FCC CLASS II PERMISSIVE CHANGE REQUEST LETTER

RE: FCC Permissive II Change Request for Company: Ohsung Electronics Co., Ltd. **FCC ID: OZ5URC-SR002C**

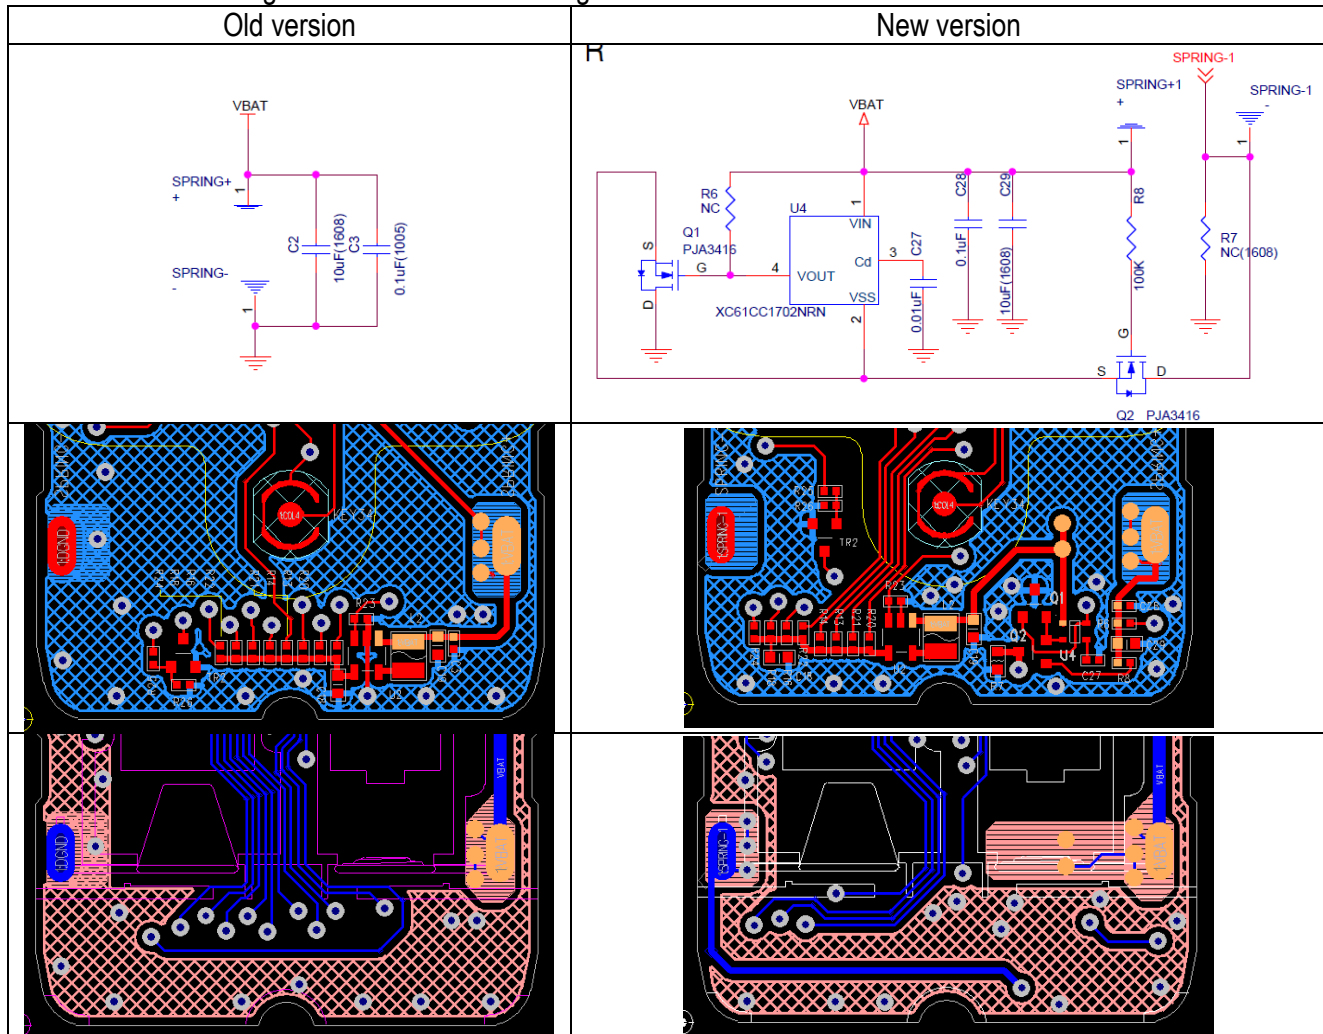
1. Main PCB version

- Old version: PFFFA1454A(OTMF-B910TYPE) 2019.09.04
- New version: PFFFA1454B(OTMF-B910TYPE) 2019.12.03

2. Information for change: Added detector of voltage on the circuit

※ Only non-transmitter parts itself has changed.
